**INDIVIDUAL EXPERT REPORT OF DR DANIEL MARTENS
TRAFFIC MANAGEMENT
8 AUGUST 2016**

Liverpool City Council v Moorebank Recyclers Pty Ltd & Others

TRAFFIC MANAGEMENT EXPERT REPORT

Prepared on behalf of Liverpool City Council

4 ATTACHMENT B – PROPOSED BRICKMAKERS DRIVE INTERSECTION

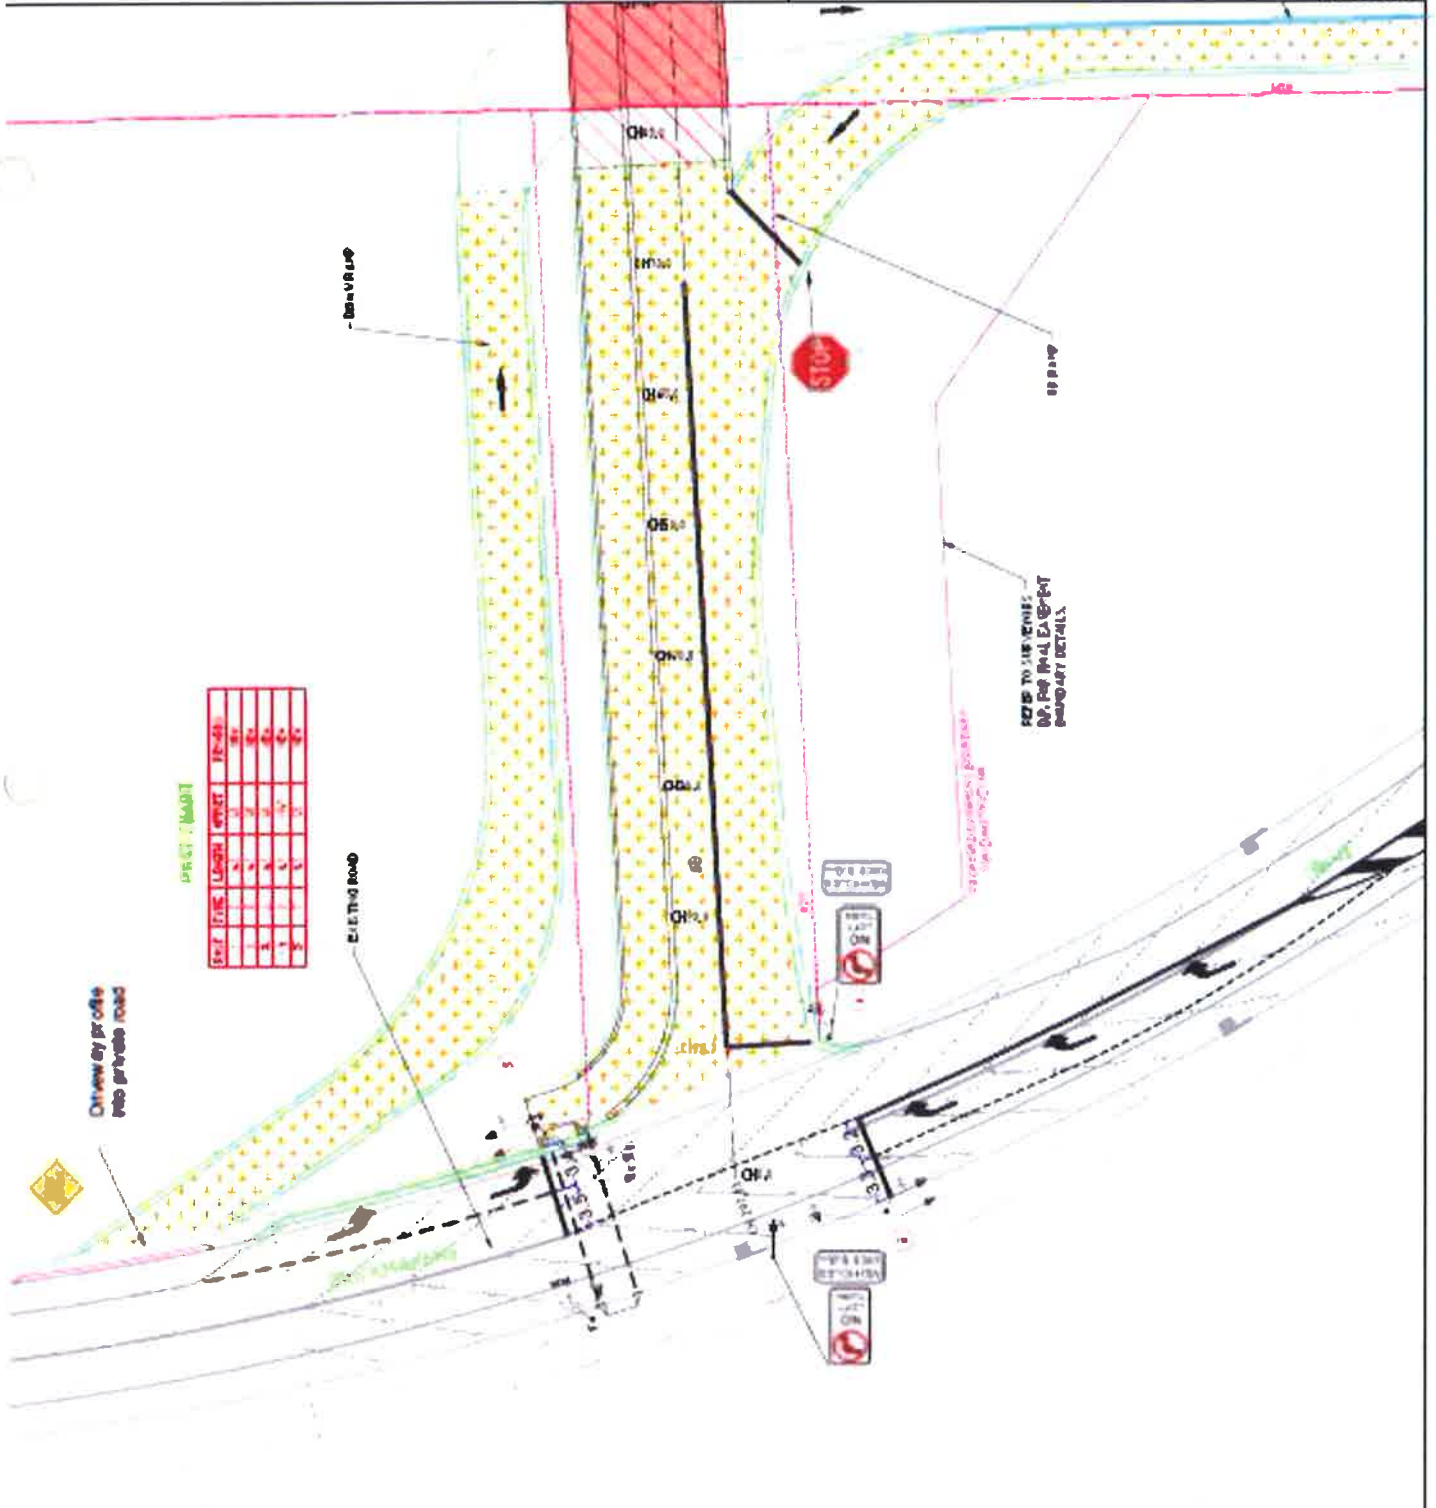
21. I make the following comments in relation to the civil design of the proposed site access driveway intersection with Brickmakers Drive as provided in the 2013 Cardno plans and 2013 McLaren Plans:

- a. The design is reasonable and provides an adequate level of separation between truck movements generated by the recycling development and future potential development serviced by the Link road.
- b. The design appears broadly capable of providing for future development to the east of Brickmakers Drive and to the north of the subject site.
- c. Swept path analysis provided in the 2013 McLaren Plans show that a 19 m semi-trailer can safely enter and exit the subject site. If B-double traffic is expected at the recycling facility, then the swept paths will need to be redone to confirm that the civil design functions for such vehicles.

29. Notwithstanding the above, in relation to the issue of traffic my assessment is as follows:
- a. The civil engineering design of the proposed access driveway intersection with Brickmakers Drive is reasonable and provides an adequate level of separation between truck movements generated by the recycling development and future potential development serviced by the Link road. Swept paths for a 19 m semi-trailer are adequate. However, if a B-double were required to access the site, then swept paths for these vehicles should be provided to demonstrate that the proposed intersection is suitable.

- b. Insufficient detail has been provided on the civil plans to show how pedestrians walking on the eastern Brickmakers Drive footpath in a north/south alignment can be safely managed.

- c. On this basis, the proponent should demonstrate that the current intersection design can be retrofitted with traffic signals at a future date, should the need arise. If the intersection requires some modification to achieve this outcome, then amended plans should be provided.

**5 ATTACHMENT C – PROPOSED INTERSECTION WITH SWEPT PATHS BY
MCLAREN**

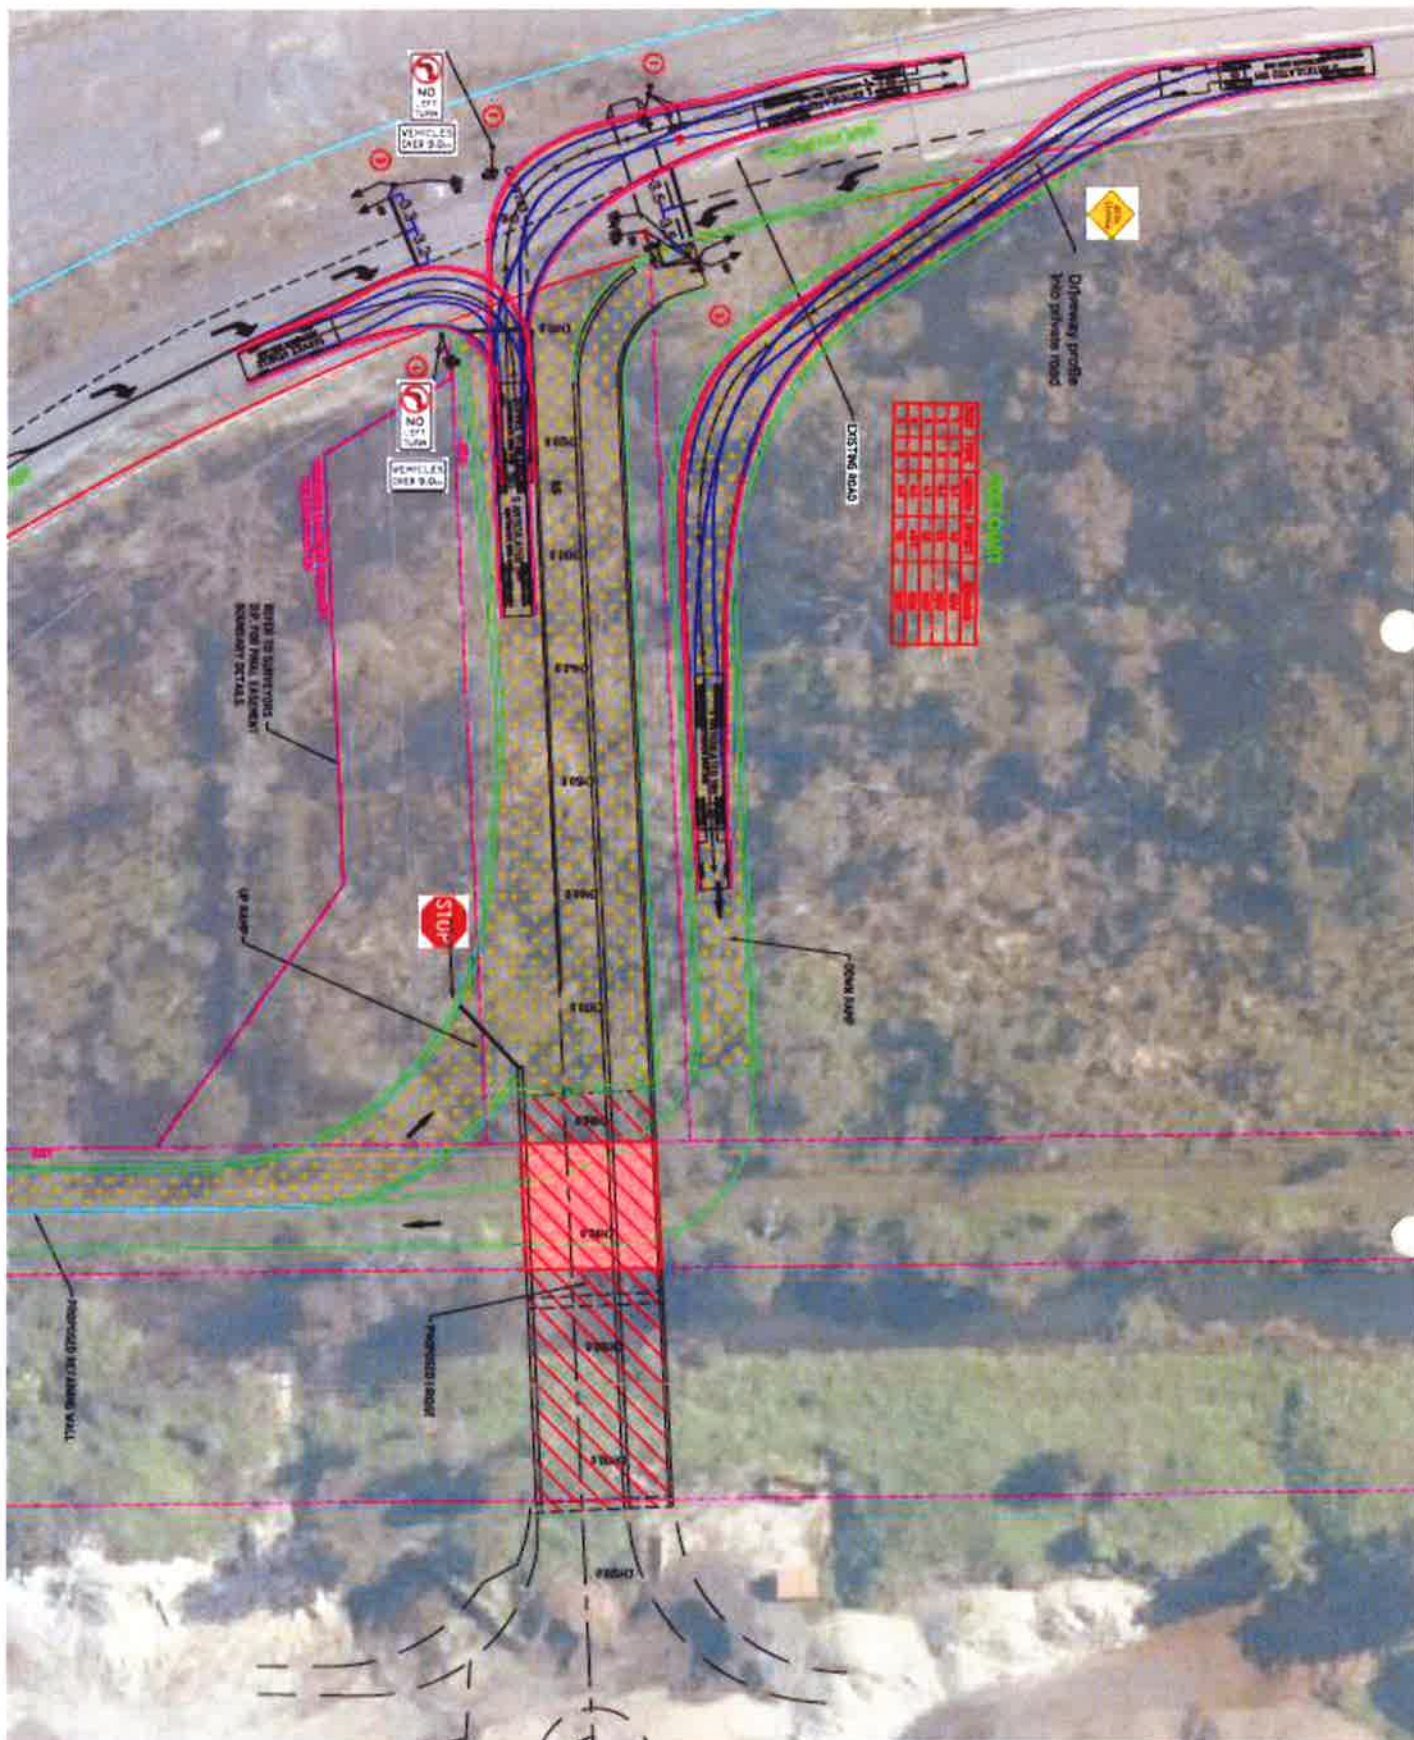
- b. Swept path and additional intersection details are provided in the 2013 McLaren Plans. An overview plan of the intersection is provided in Attachment B to this report, with swept paths provided in Attachment C. The following is noted:

- i. Swept paths for a 19 m semi-trailer utilising the left turn in ramp are satisfactory.
- ii. Swept paths for a 19 m semi-trailer utilizing the right turn out movement are satisfactory.
- iii. No left hand turn out for vehicles over 9 m is nominated. Swept paths for these smaller vehicles are satisfactory.
